Enclosure No 1
to
Bulletin No BO-112/2005 SWIFT S-1

**WORKING INSTRUCTION
INSPECTION OF CONTROL COLUMN
IN ELEVATOR CONTROL SYSTEM
OF SWIFT S-1 GLIDER**

**This a.m. document has been adopted at Zakłady Lotnicze for the purpose of
Bulletin No BO-112/205 SWIFT S-1.**

picture 2 : Elevator control column

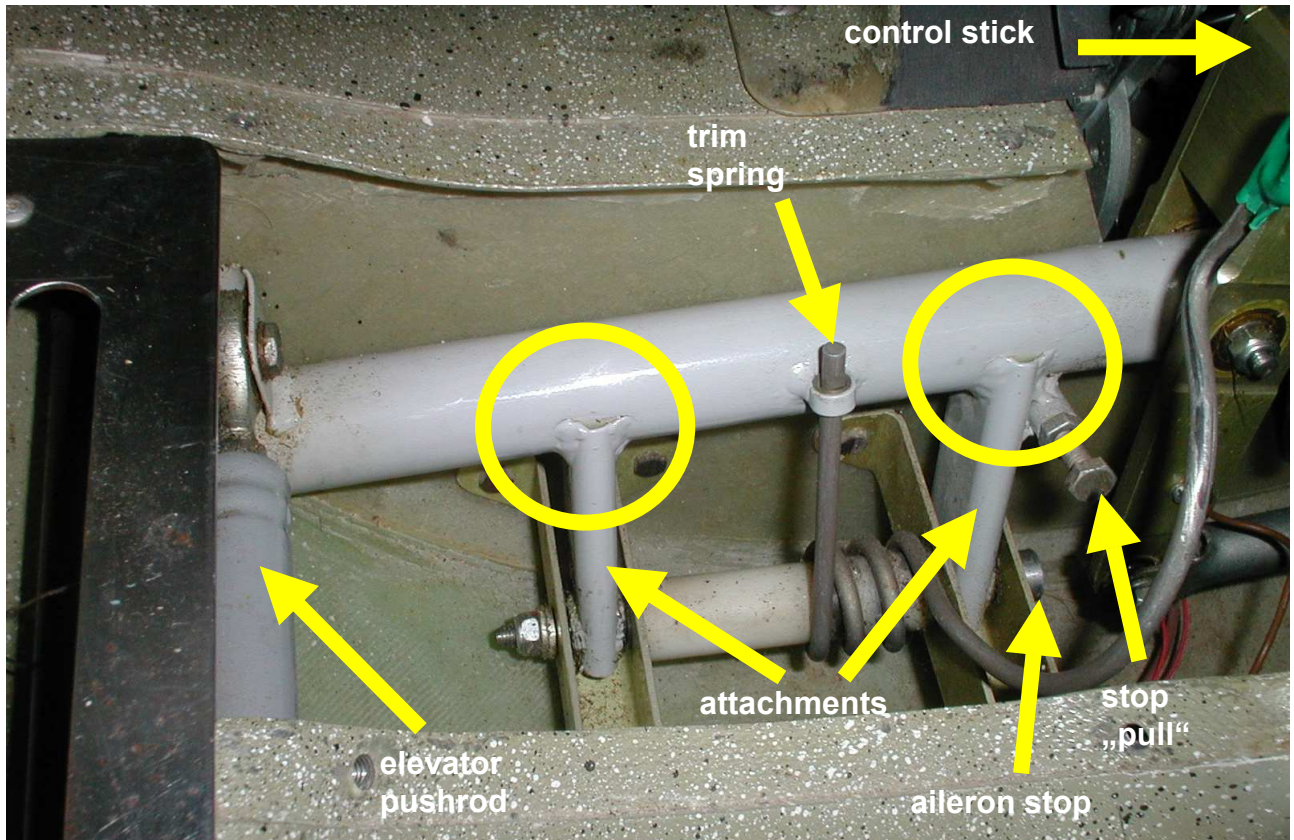
- I) Dismantle the control stick cover and remove the left (in flight direction) access cover of the controls close to the control stick (s. picture 1).
- II) Inspect the welding seams of the attachments (see circles in picture 2) over the whole length for cracks and other damage; use a strong pocket lamp and a mirror - if necessary. If crack or other damage is found, the control column must be replaced.

picture 3: Damage viewed from front

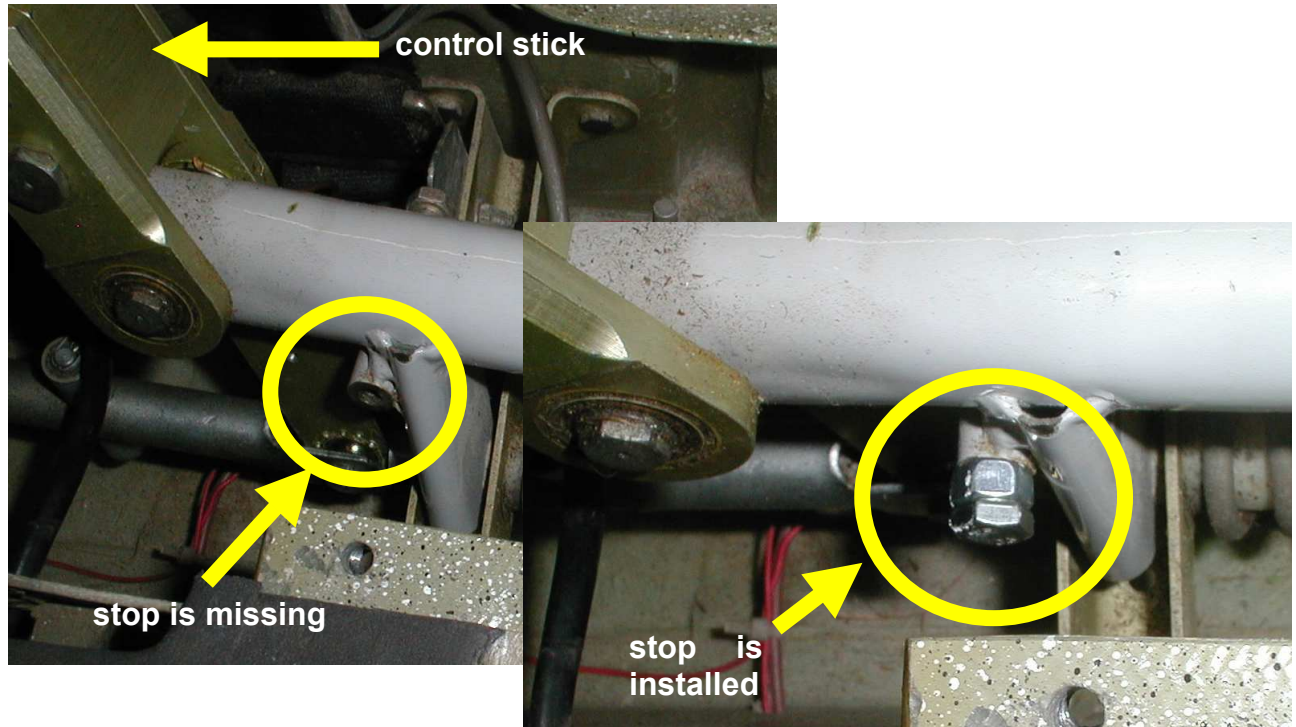
picture 3 and picture 4 show a sample of the possible damage.

- III) Check if a stop is installed on the control column for the „nose down“ (push) position. If no stop (bolt M6) is found, this must be retrofitted according to part 2 of this Working Instruction.

picture 6: Control column pushed fully forward until the stop

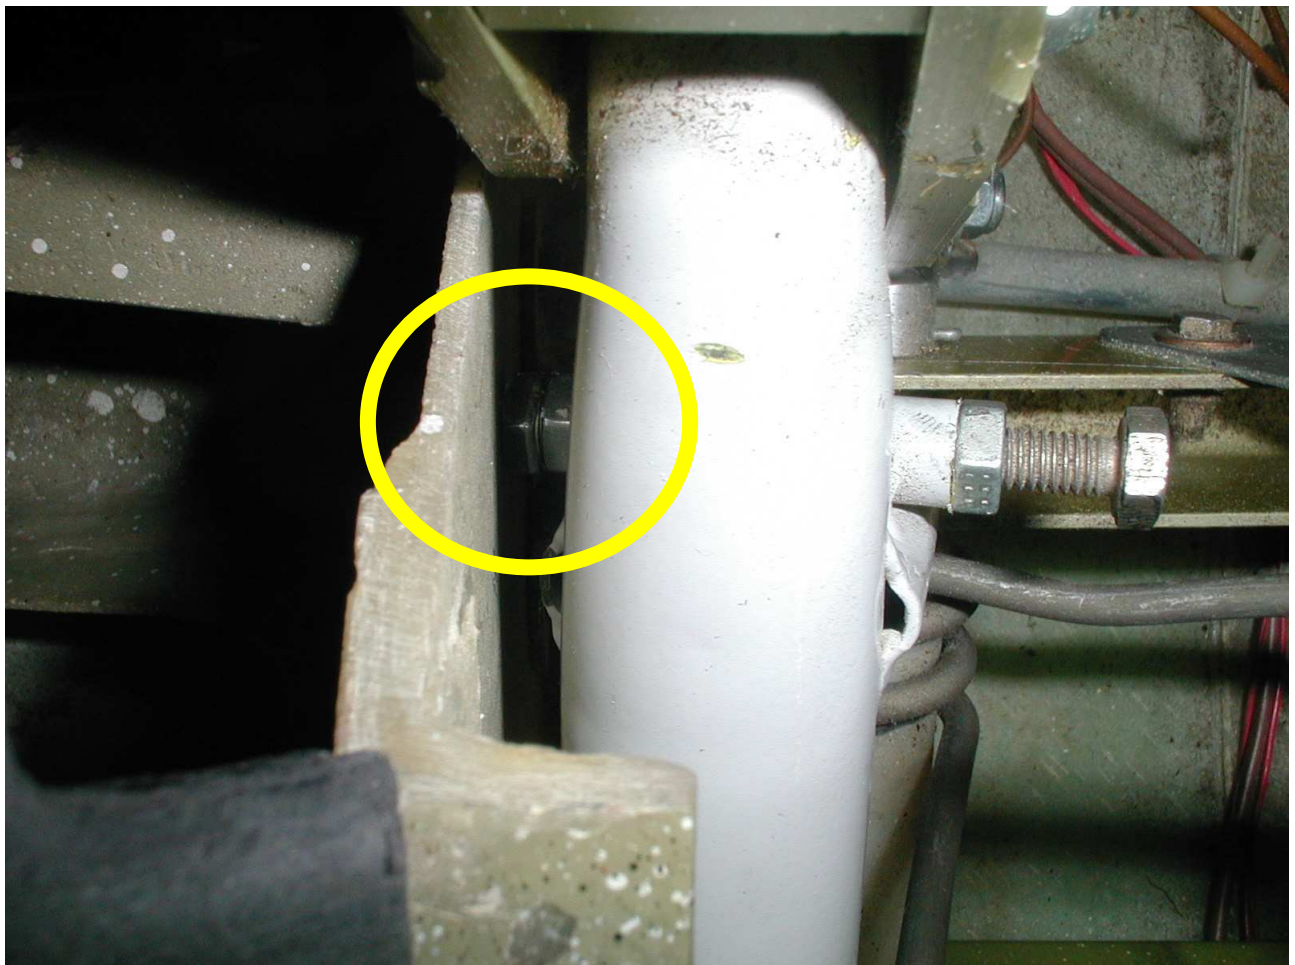
The bolt M6 x 20 must be screwed into the existing thread on the front face of the control column and locked with the nut M6 (see picture 5).

The bolt must be screwed in at least 10mm deep into the thread of the column.

The head of the stop bolt must be adjusted so to hit the front control bulkhead prior to the contact between attachment of the elevator push rod at the outer side (sheet metal-U, see picture 7) and GFRP frame!

picture 7: Swivel-head at the elevator pushrod fixed by a locknut and secured

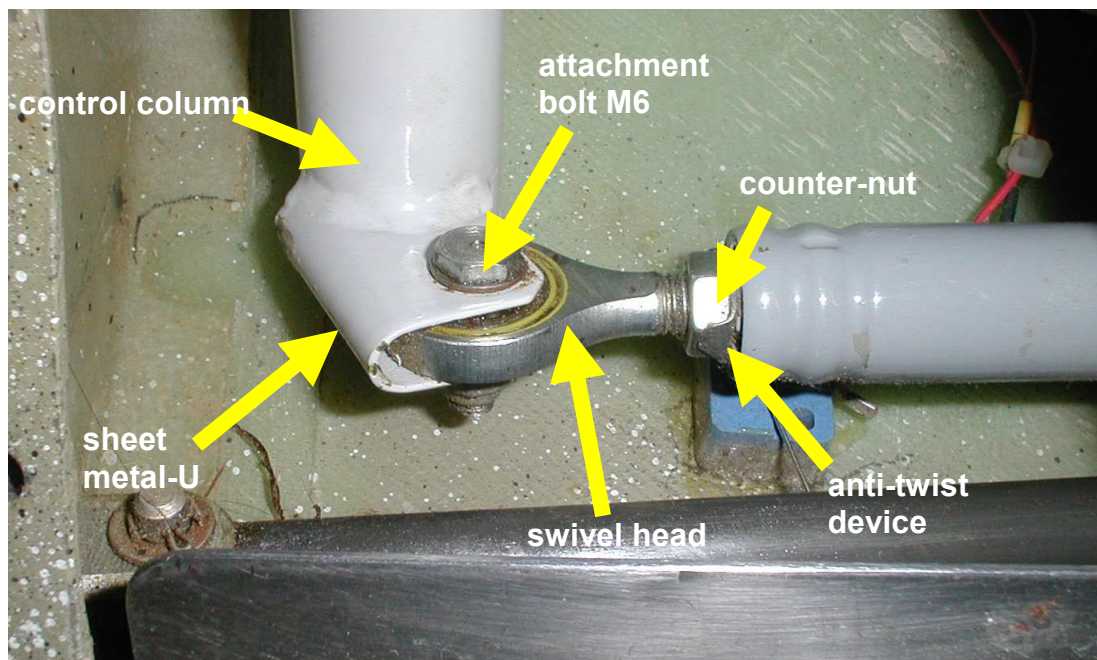
If the elevator deflections according to the Technical Service Manual (figure 1, page 7) are not available now, the swivel head at the end of the elevator push rod on the left side of the column must be adjusted.

To do so, untighten and disconnect the bolt M6, one connecting the push rod end with the column, mark the positions of the washers and keep all these items. Bend off the anti-twist lock at the counter-nut (sheet metal clip), unthighten the counternut and screw the swivel head into the pushrod until the elevator deflections in „nose down“ direction reach the required value (see picture 7 and picture 8).

picture 8: Swivel-head disconnected and counter-nut untightened

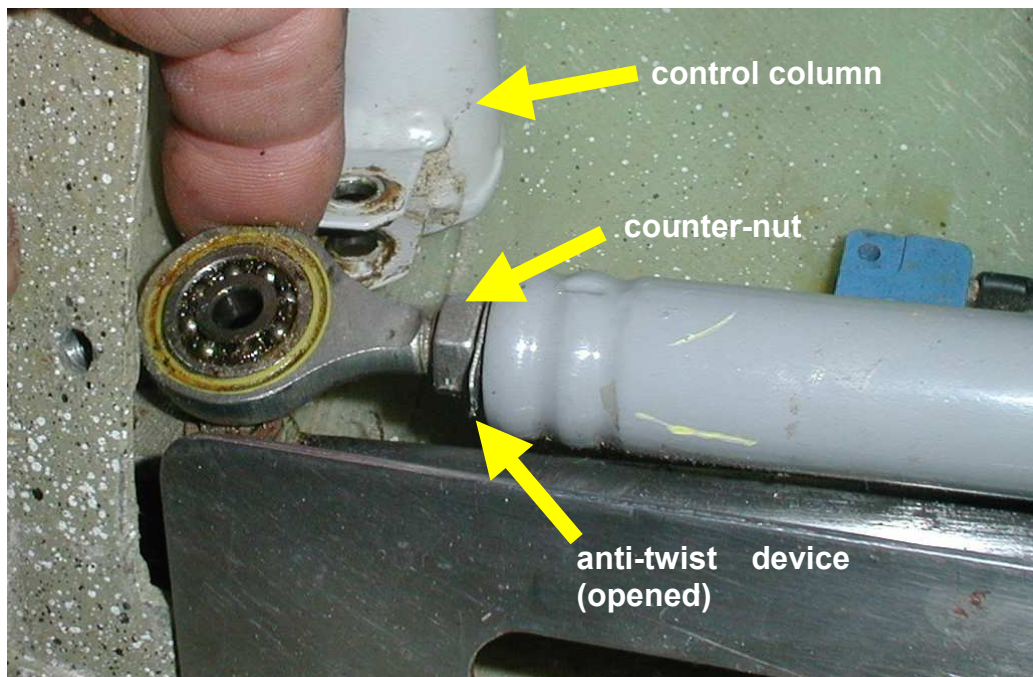
If the swivel-head at the elevator pushrod had to be adjusted, the aft („nose up“) elevator stop has to be readjusted as well.

To do so, untight the counter-nut of that bolt and screw the bolt into the mounting, until the full range of elevator deflection both up and down will be reached, (but not more!) according to the Technical Service Manual. Tighten the counter-nut again afterwards.

Finally, tighten the counter-nut of the swivel-head and secure it against loosening with the anti-twist device. Connect the pushrod with the control column by means of the M6 bolt, use the washers as marked when disassembling the set. Use a new lock nut M6.
